## Design Review Subcommittee (DRSC)

Meeting Date: February 28, 2024

**SUBJECT:** **Development Permit (DP) 23-416, Bauder Addition,** a request to consider a 603 square foot 2<sup>nd</sup> story addition and balcony addition to an existing single-family residence located at 106 W Paseo de Cristobal within the Residential Low Zone and Coastal Zone Overlay (RL-CZ) adjacent to a historic structure located to the northeast of the subject property.

**Image 1 – 3D Rendering of Front View****RECOMMENDATIONS:**

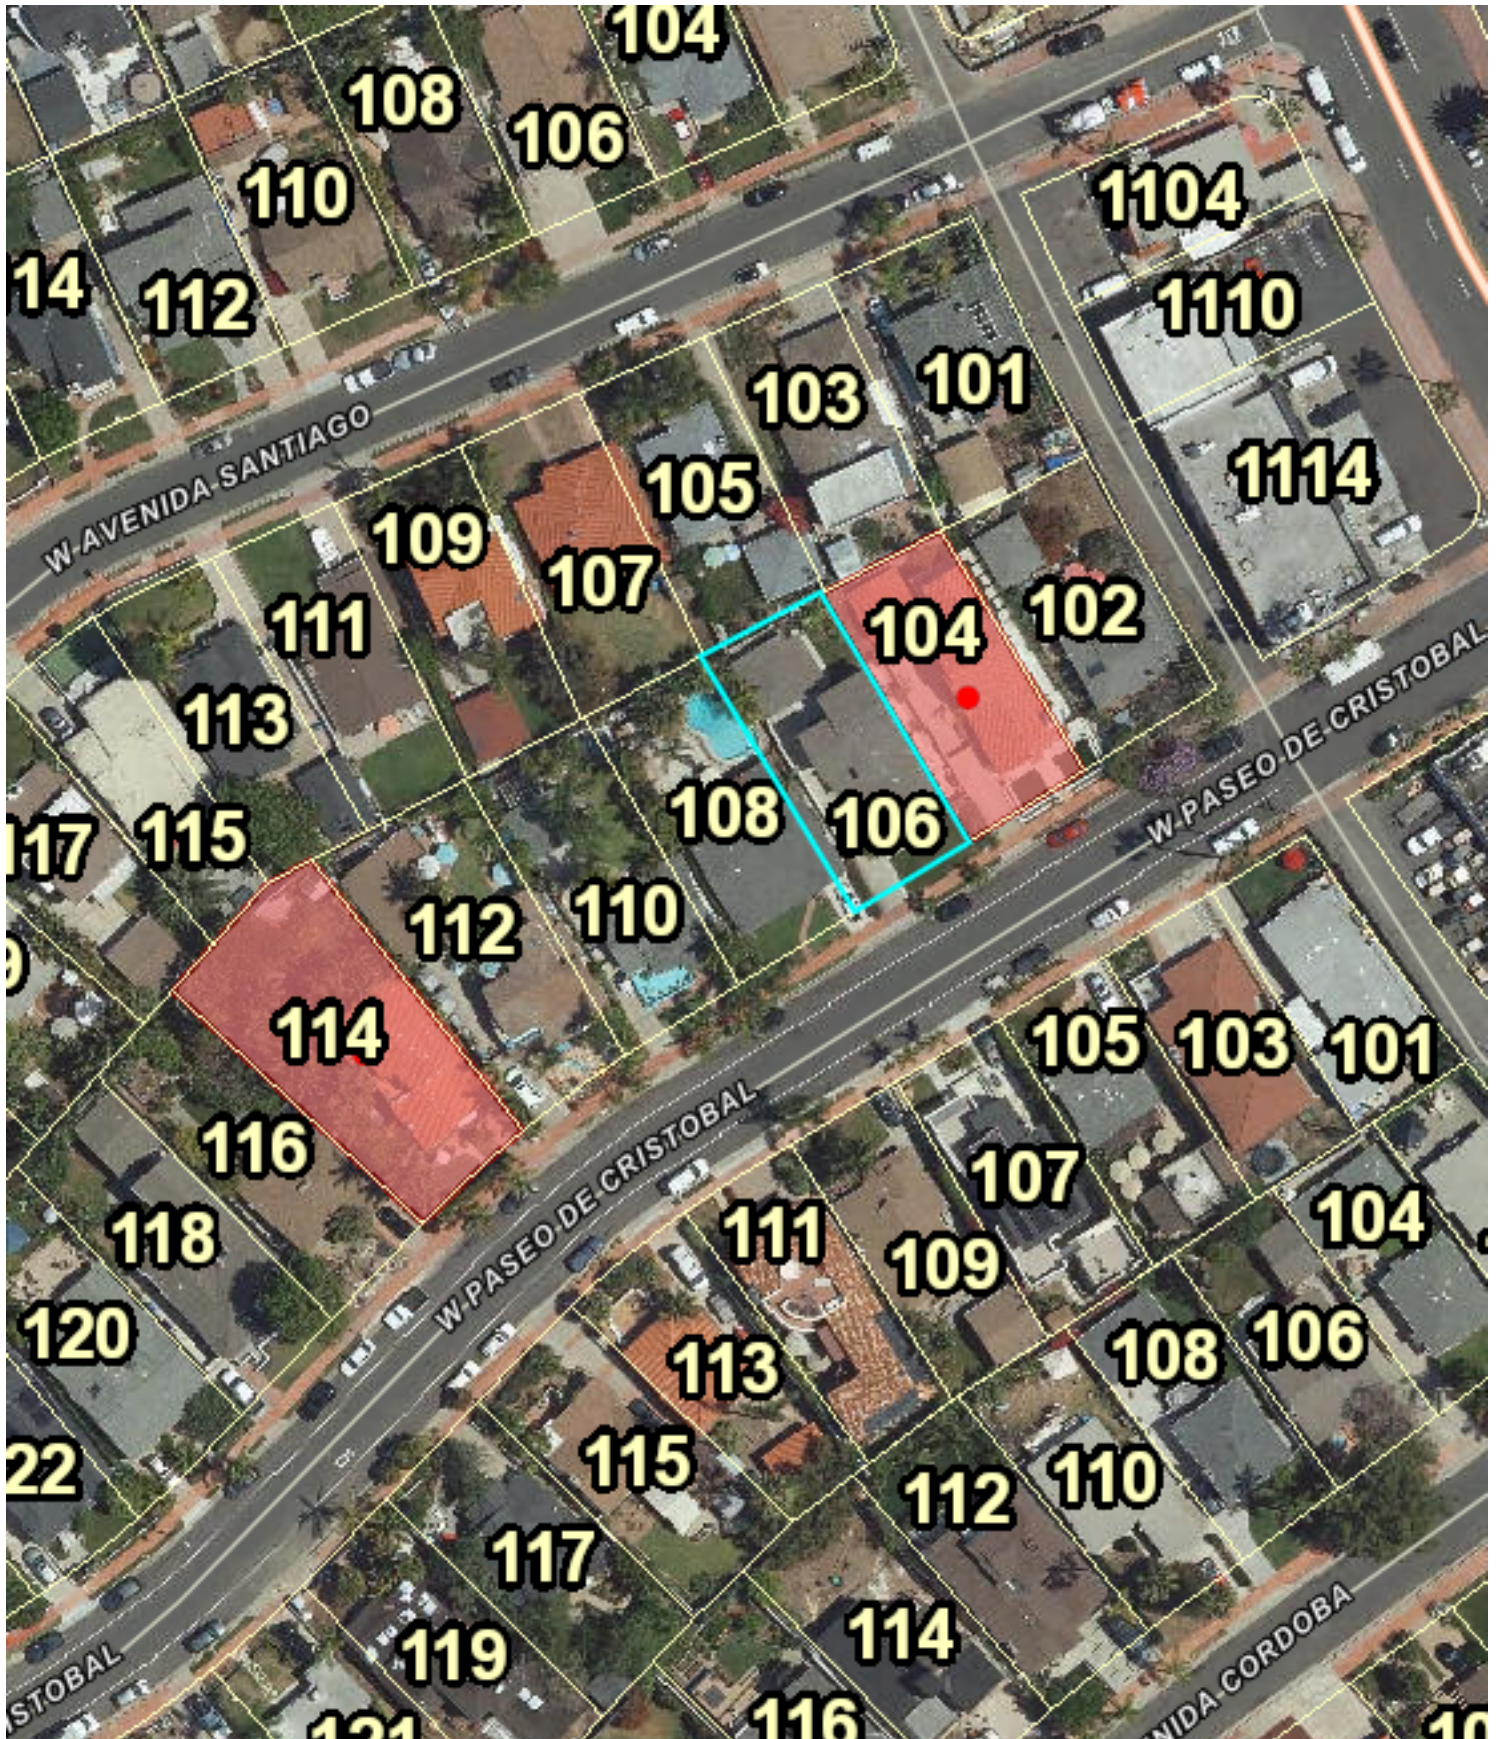
However, the rear wall plane on the east elevation, and the entire rear elevation, consist of white stucco as the only wall surface material. Staff recommends that plank siding be added to each of the elevations, for consistency with Design Guideline II.B.3. which states, *"Carefully design rear and side facades to be compatible with the principal facades of the building."* At a minimum, plank siding should be added to the rear wall plane on the east elevation which is visible from the street and the adjacent historic residence. Image 1 below is a 3D rendering of the front of the project highlighting the subject rear wall plane on the east elevation.

1. Add keynotes to the plans that specify the details of the materials proposed. The provided 3-D renderings will supplement these keynotes.
2. Plank siding should be added to each of the elevations, for consistency with Design Guideline II.B.3. which states, *“Carefully design rear and side facades to be compatible with the principal facades of the building.”*

PROPOSED ELEVATIONS

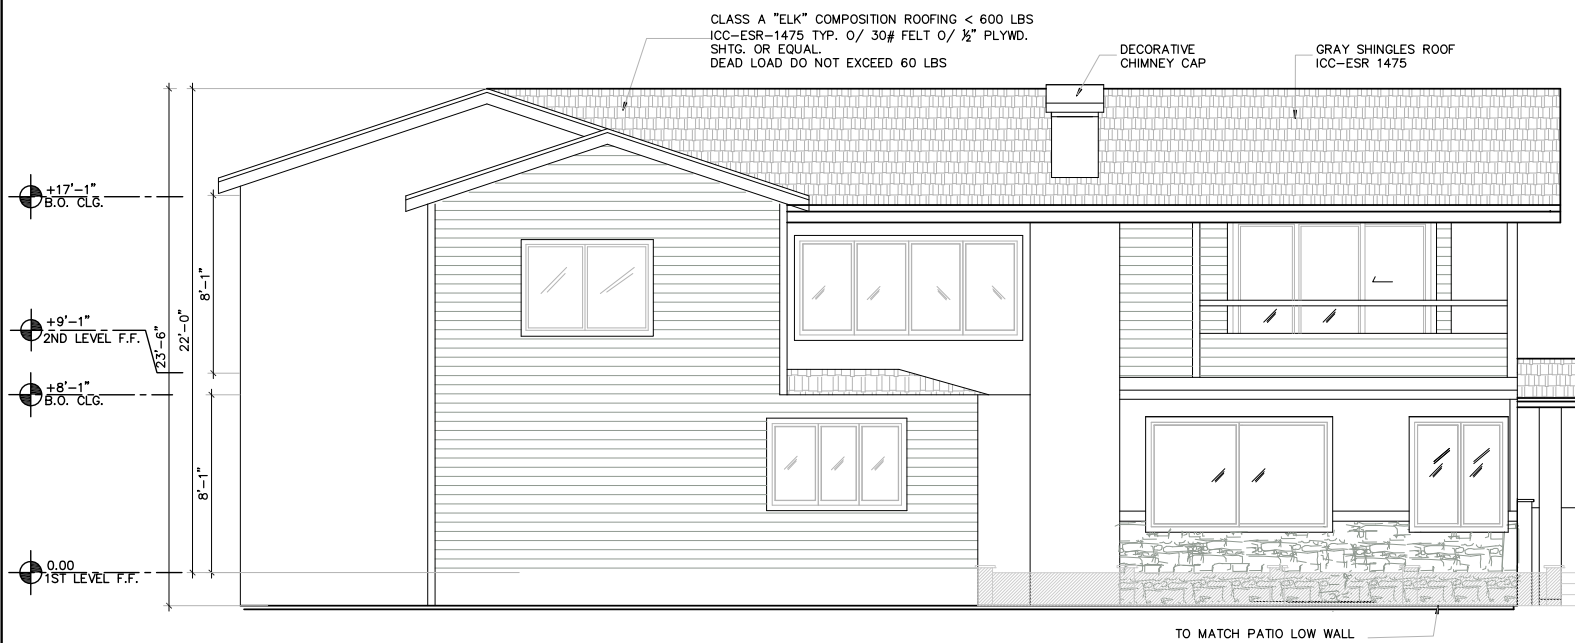
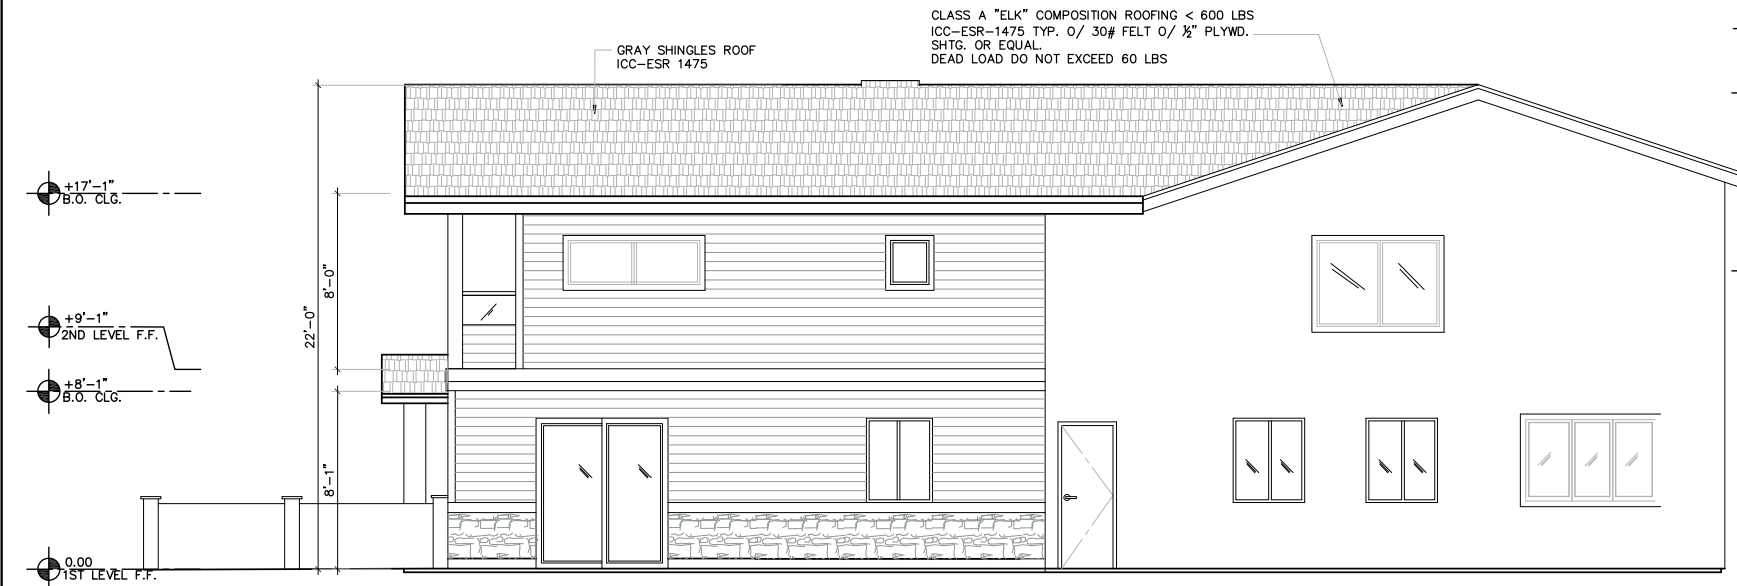
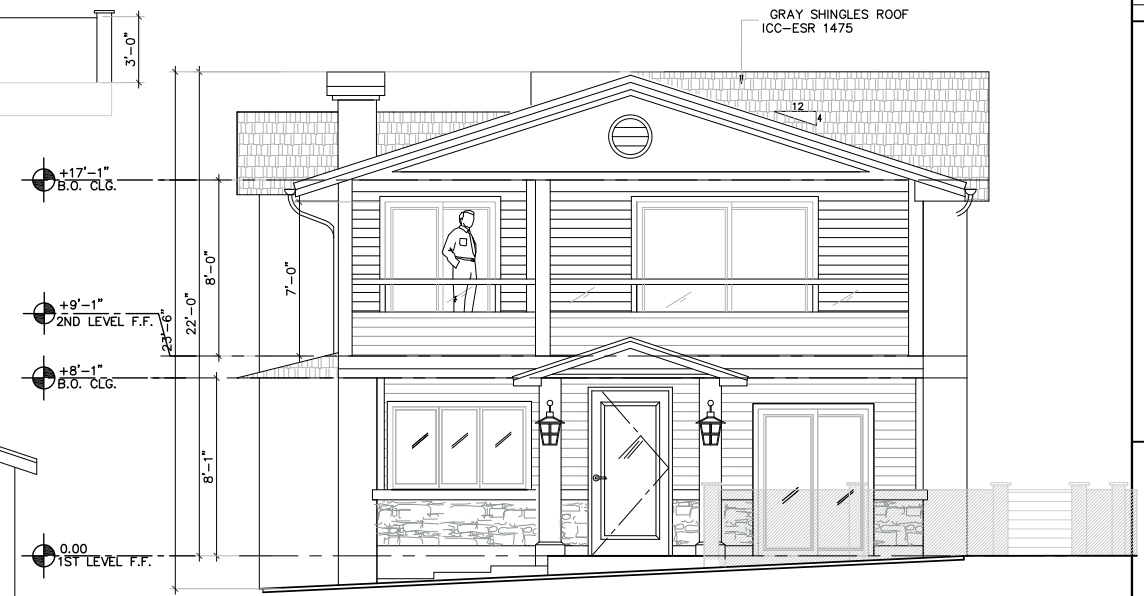
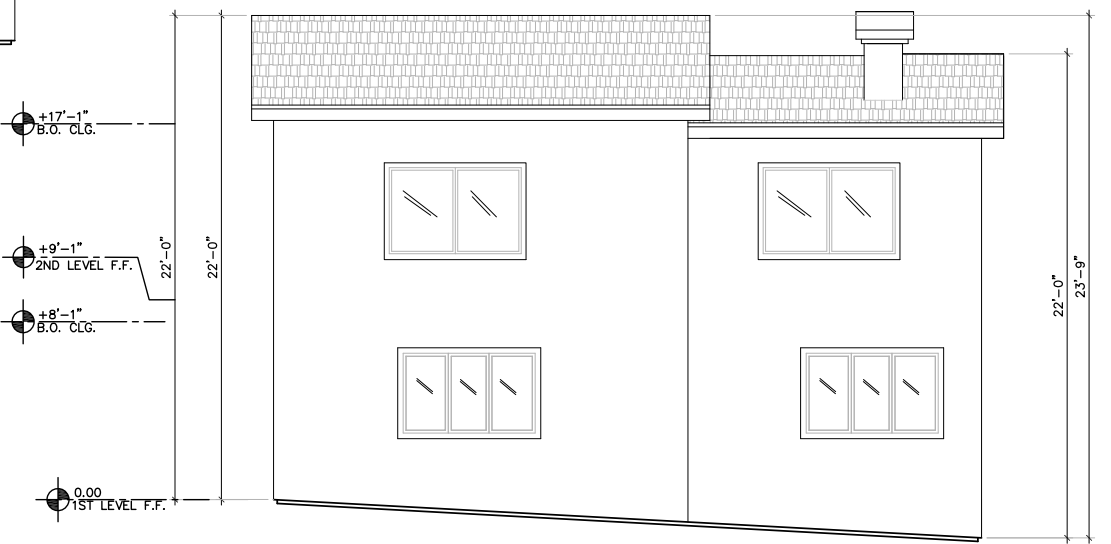
2. Discouraged competing roof pitch elements on the west elevation. Explore the idea of raising the plate height of the addition.	The project plans show a consistent 4:12 roof pitch across the elevation, removing the different roof pitches along the west elevation. The front elevation shows a new front gable end, which adds consistency across the front elevation. The total height of the addition remains the same.

- A partial stub wall with pickets above would provide some additional privacy and screening for the proposed master bedroom.
- Discouraged the competing roof pitch elements on the west elevation. It was encouraged to explore raising the plate height of the addition, which could address the inconsistency in the roof pitches.

- A partial stub wall with pickets above would provide some additional privacy and screening for the proposed master bedroom. / [See new Design](#)
- Discouraged the competing roof pitch elements on the west elevation. It was encouraged to explore raising the plate height of the addition, which could address the inconsistency in the roof pitches. / [See new Design](#)

Prior Design Submittal, November 29, 2023

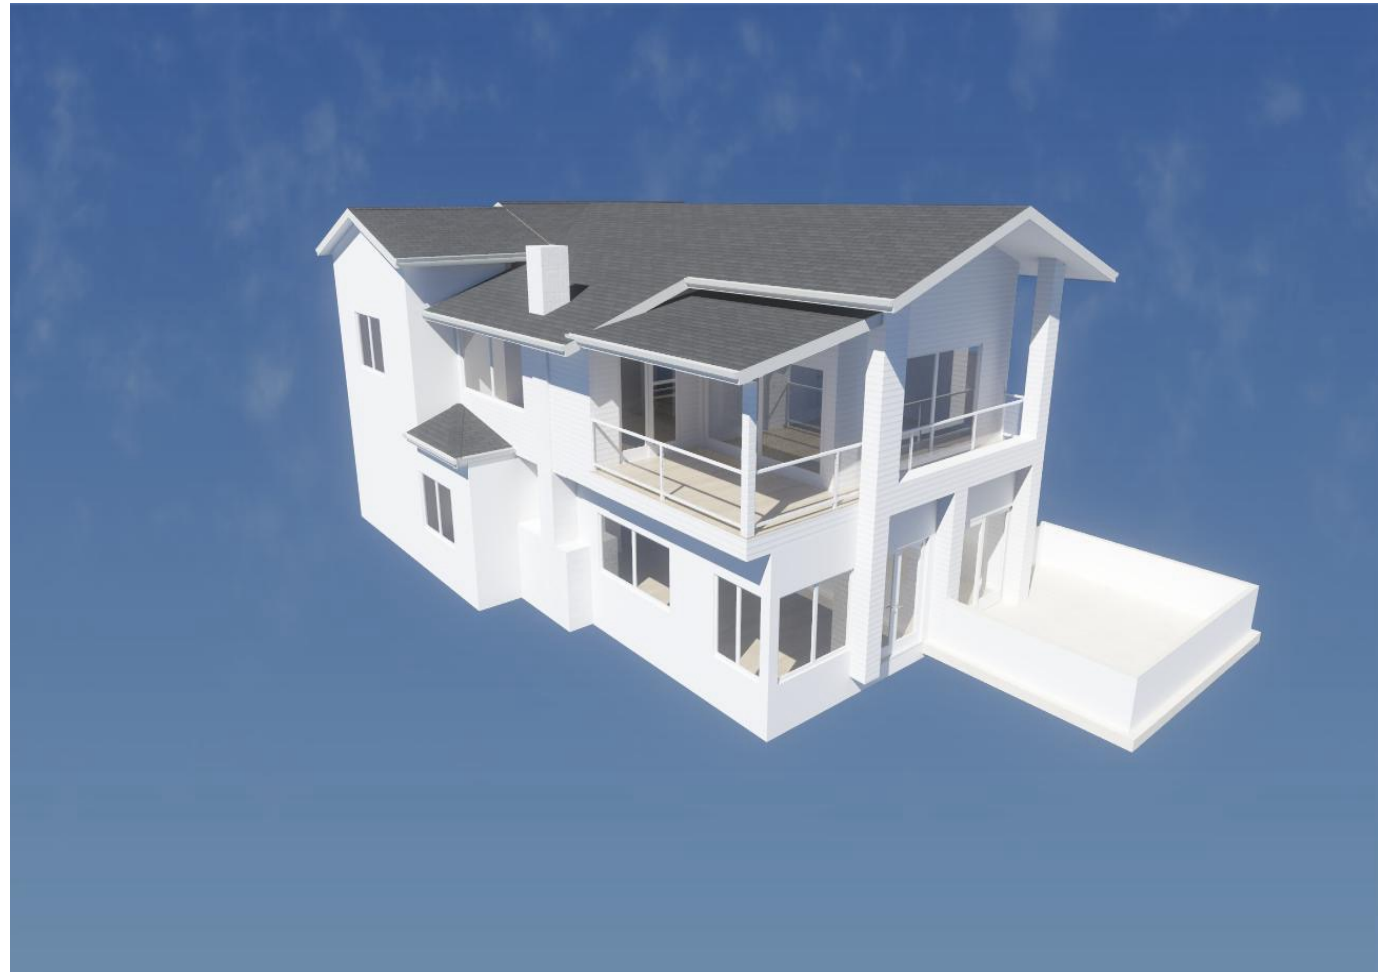
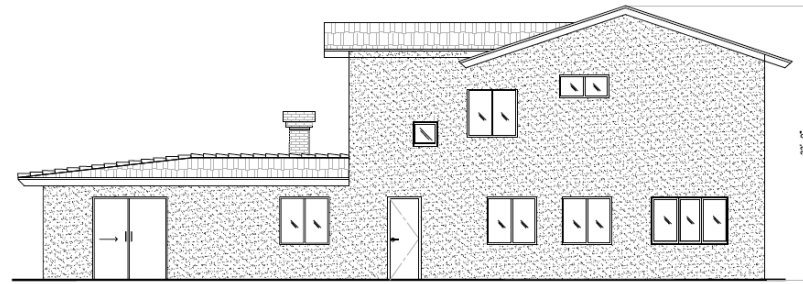
- Additional privacy recommended for balcony (stub wall)
- Discouraged competing roof pitch elements
- Proposed elevations were difficult to read
- Recommended a holistic review, to include landscaping
- Encouraged a more simplified design; questioned the use of the large columns
- Requested an architectural style be selected
- Recommended keeping the garden patio and integrating it with design

- Style: **Beach Cottage**
- Adds master bedroom, bath, additional common Space
- Finishes second story
- Ties existing patio into new design, integrates landscaping
- Exterior design changes since first Design Review Meeting on November 29
- Design is simplified, adds higher quality materials

- Front gable is closed in as recommended by Design Review Subcommittee
- Additional landscaping coordinates with patio design; added walkway leading to front door
- Eliminates competing roof pitch elements on west side
- Maintains setback on east side to adjacent historic residence (9' 4", 26' to adjacent residence)
- Upstairs balcony setback of 3' retained
- Decorative lighting
- Front setback requirements met
